BLOOMINGTON PLAN COMMISSION
STAFF REPORT
Location: 314 E. 3rd St.

CASE #: SP-32-13
DATE: September 9, 2013

REQUEST: The petitioner is requesting site plan approval to allow a three-story mixed-use building.

Subject: SP-32-13, Tiffany Clark
314 E. Third Street
Second Hearing for Site Plan request

SP-32-13
Site Plan

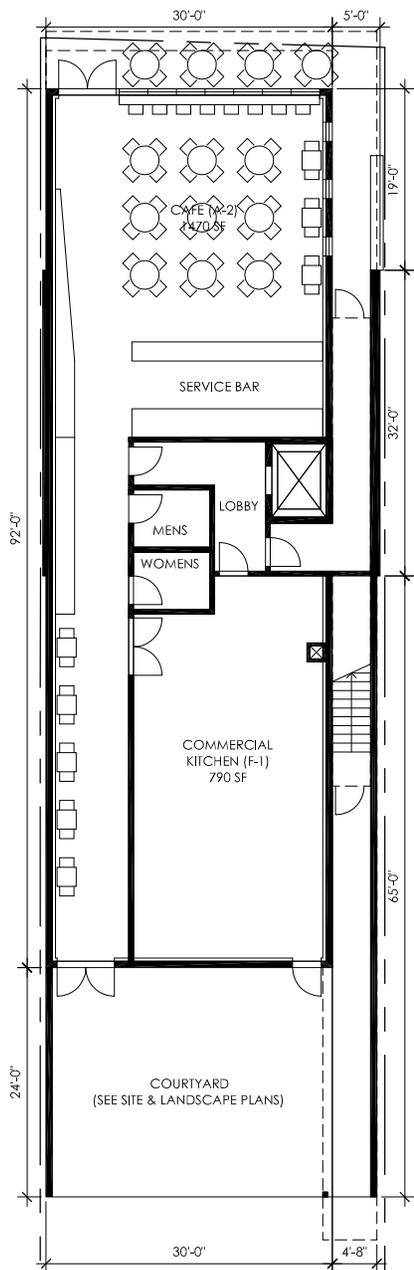
Side Setback Waiver - 20.03.260(d)(3): A waiver is required to build a building with zero foot side setbacks. The property is a long and narrow lot, 36 feet wide by 148.5 feet deep. The property to the west is a similar size and has been developed with a laundromat with zero foot side setbacks. The building to the east has been developed with an approximately 24 foot side setback. The proposal includes a five foot side setback with some window openings along a few portions of the building to mitigate some of the visual impact along E. 3rd St. The Downtown Plan makes no specific recommendations concerning side setbacks, however it does recommend that in the Downtown Edges Overlay that buildings be designed to be compatible with existing surrounding residential context. In this location there is no residential context along the south side of 3rd Street. Adjacent buildings are commercial in nature and will likely be redeveloped in the future. Staff finds that the narrowness of the lot makes abiding by the setback requirements difficult. If the setback was maintained, there would only be 22 feet of buildable area on this lot. Staff finds that while this reduced setback would prohibit larger windows on the east side and any

Parking setback: The DEO requires a minimum side yard parking setback of seven feet. The very narrow property width (36 feet) does not allow for full compliance with the parking setbacks. If the site plan complied with the parking setback standard there would only be room for 2 parking spaces.

Side Parking Setback Waiver - 20.03.260(c)(1)(B): A waiver is required to allow a parking setback of less than 7 feet on the west side of the lot. The property is only 36 feet wide. The properties to both the east and west have been developed with zero side parking setbacks. The Downtown Plan makes no specific recommendations concerning side parking setbacks. Adjacent buildings are commercial in nature and will likely be redeveloped in the future. The proposed building itself will also screen parking from the street. Based on the narrow lot width, the desire to increase parking and the fact that the neighboring properties have zero setbacks, staff finds this waiver appropriate.

Impervious Surface Coverage: The DEO allows a maximum impervious surface coverage of 70% of the lot. The petitioner is proposing 84% impervious surface coverage. The outdoor courtyard will be pervious pavers providing 16% pervious surface area on the lot.

Impervious Surface Coverage Waiver - 20.03.260(a)(2): The UDO does not permit green roofs to count as pervious surface. However, if the green roof were counted as pervious surface, the property would nearly meet the maximum impervious surface coverage percentage (maximum: 70%, proposed 72%). The UDO encourages green development features such as green roofs to be taken into account when considering waivers, and staff believes the green roof and pervious pavers meet the intent of the maximum impervious surface coverage standard. Staff recommends approval of this waiver.

2. Prior to release of a building permit, the petitioner must have completed quiet title action to secure ownership of a two (2) foot deed gap.
3. Proposed walls around the rear courtyard shall not exceed eight (8) feet in height per UDO requirements.

4. Prior to release of a building permit, the petitioner shall secure and record access and maintenance easements from the property owners to the east and west to ensure the long term maintenance of the building.

5. Final City Utilities approval is required prior to release of any permits.
6. A minimum of 4 bicycle parking spaces shall be provided at the front of the building.

SP-32-13
Front and Rear Color Elevations

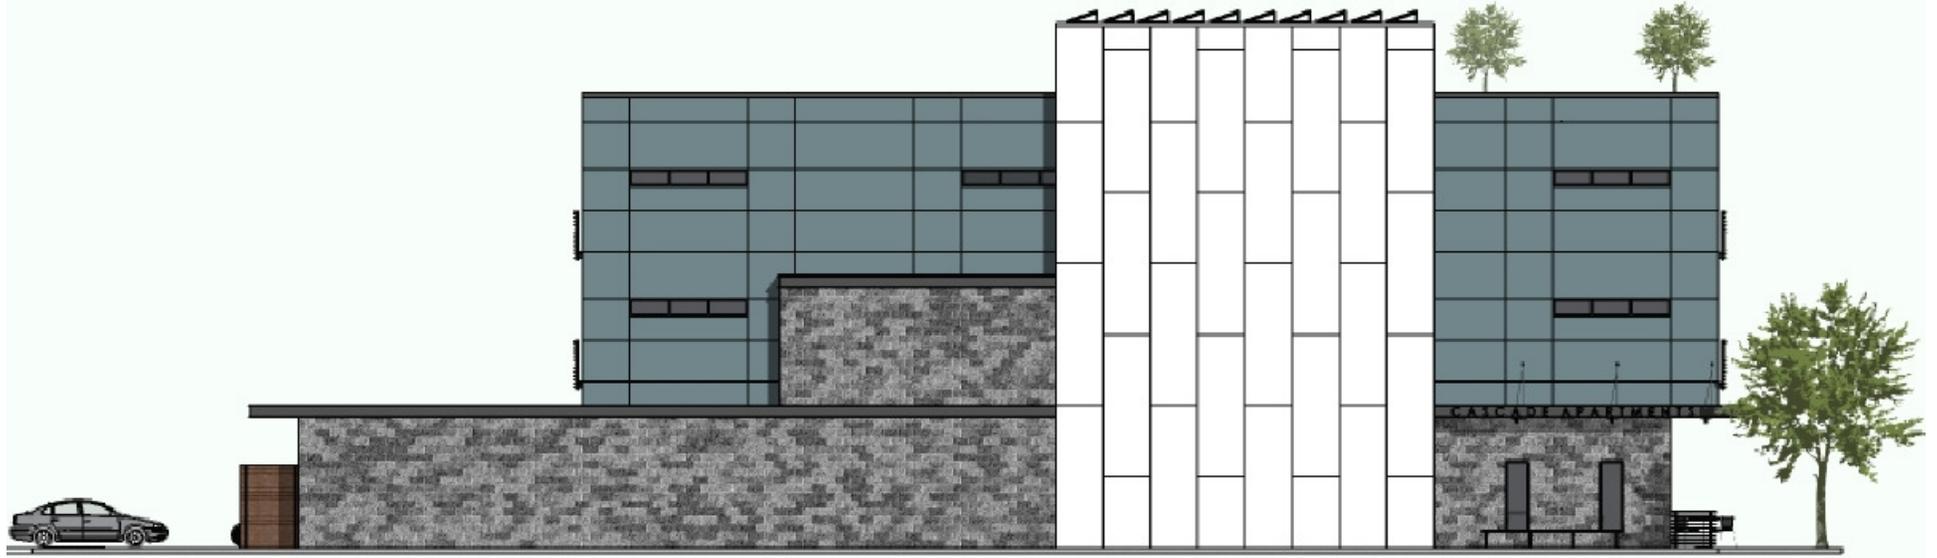
Exterior Finish Materials: The proposed building will be primarily finished with fiber cement panels, split face concrete masonry units (CMUs), and metal-framed glass. Split face CMUs, metal-framed glass, and metal are proposed as secondary finish materials. Since the last hearing, the amount of CMU on the east side of the building has been reduced. Elevations and renderings have been included in the packet.

Primary Exterior Finish Material Waiver – 20.03.340(b)(4)(B): A waiver is required to allow split face concrete masonry units as a primary exterior finish material on the east side of the building. On the west elevation, it is used as a secondary exterior finish material, which is permitted. CMU makes up about 22% of the east side elevation. The maximum for a secondary material is 20%. While the split face CMU may be less visible in the future as new buildings are built on adjacent lots, at this time it will be visible from E. 3rd St. Staff finds that the use of CMU is appropriate, given that this base material will be screened then redevelopment of adjacent lots occurs at some point in the future. The use of CMU, with the color and patterns proposed and in context with the other materials lends

The DEO requires that upper story windows have the visual appearance of double hung windows. The proposed upper story apartment windows are not proposed to have the appearance of double hung windows.

The architecture proposed echoes traditional building form without imitating older historic styles, and staff believes that double hung upper story windows would not be in context with the modern design of the building and the proposed Juliet balconies. Staff recommends approval of this waiver.

SP-32-13
Side color elevations

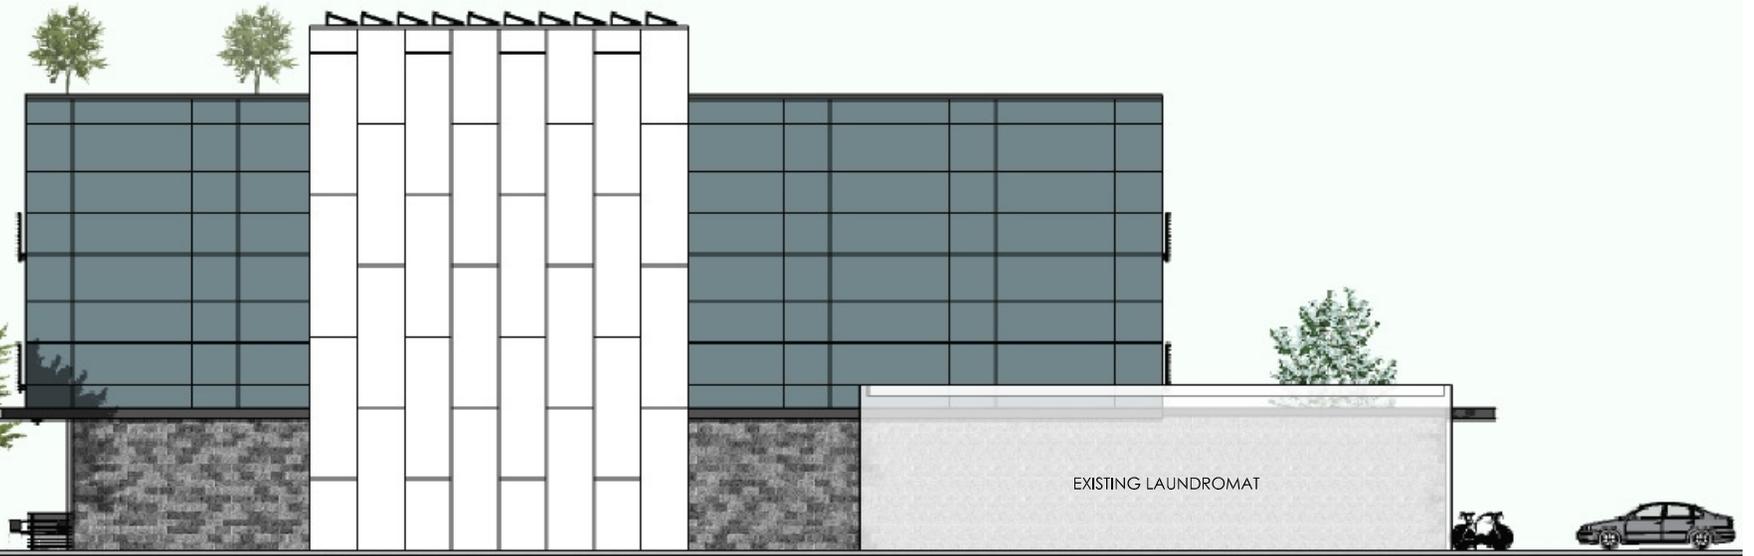
Height: The DEO district specifies a maximum structure height of 35 feet. The proposed structure has a height of 44 feet from the lowest elevation along the building to the highest point on the partial 4th floor roof. The partial fourth floor patio roof is stepped back 23 feet from the northern front façade along E. 3rd St. The height to the top of the third story is 38.5 feet.

Height Waiver - 20.03.260(b)(2): A waiver from the standards of the Unified Development Ordinance (UDO) is required to allow a height of more than 35 feet in the DEO district. The 2005 Downtown Vision and Infill Strategy Plan (hereafter referred to as “Downtown Plan”) states that a perceived building scale of two to four stories should be maintained in the downtown. It recommends that the mass of a taller building be stepped down to a lower height as it approaches traditional buildings nearby. There are two historic buildings on the same block as the subject site, the Boys and Girls Club and the Home Laundry Building but neither is adjacent to this site.

Window Design: The Downtown Plan discourages blank walls. However, the building code restricts windows along zero foot side setback lines in anticipation of future buildings also built with zero lot lines. Some small windows are proposed on the east side of the building in areas where building façade modulation will allow them.
